Re: FCA Response to NMFS letter dated September 3, 2009

Re: Assessment of status of Farmers Conservation Alliance (FCA) Horizontal Screens as an Experimental Fish passage Technology

FCA Response to Enclosure 3

The following document is Farmers Conservation Alliance's (FCA's) response to the Widow's Creek Site Inspection performed by Melissa Jundt and Michelle Day of National Marine Fisheries Service (NMFS) on August 13, 2009.

Image 1, organisms found on the screen

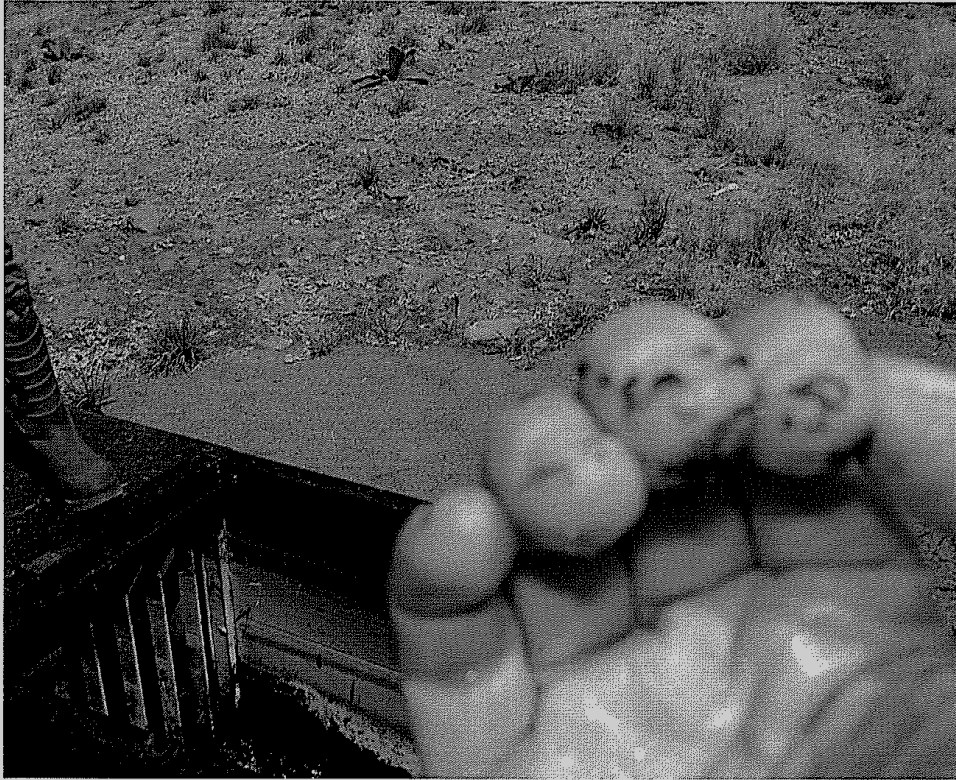
Typical of most northwest stream and river systems, inflow from Widow's Creek conveys a significant sediment and debris load. During this visit I noted that each of the three screens had some degree of debris occlusion comprised of a mixture of inorganic and organic debris (Caddis Fly, organisms that may have been Western Brook Lamprey ammocoetes or aquatic insects, small gravels, algae, and various forms of other organic materials, see Image 1). Regular fouling occurs and is documented as significant at times (see Image 2). ODFW and the ranch manager stated that the screens require cleaning at least one time per day.

Image 6, downstream screen operating water depth

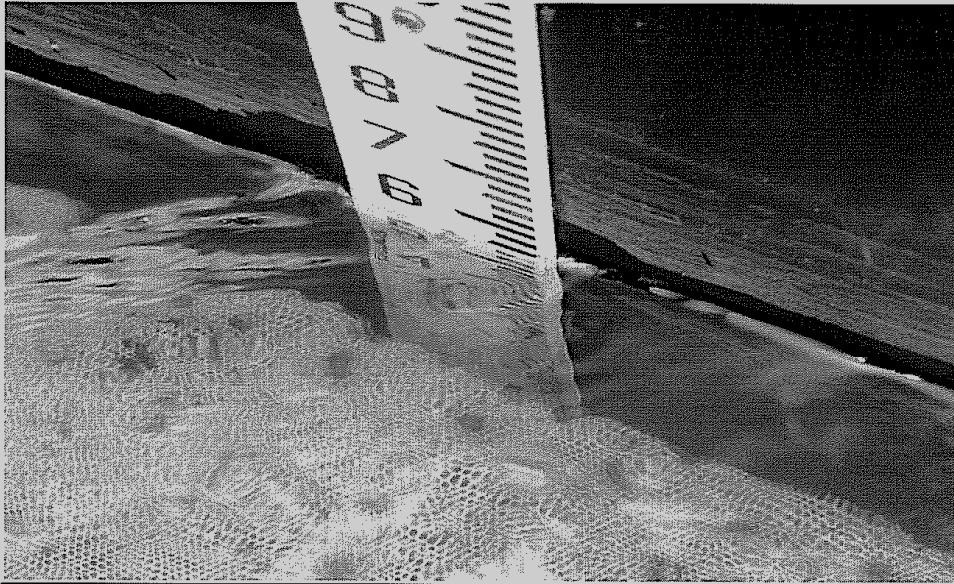
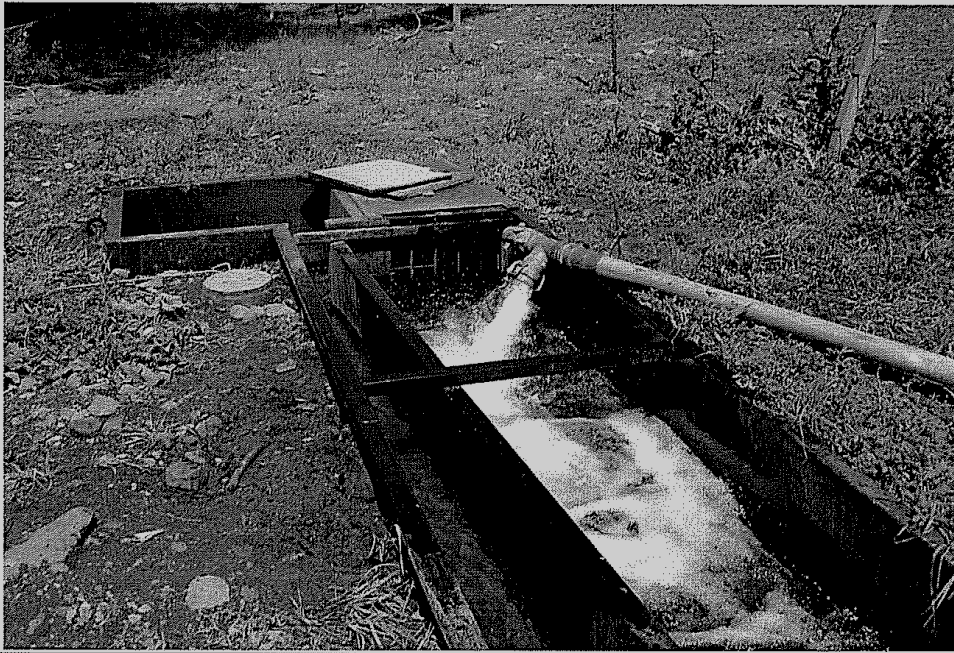
FCA Response:
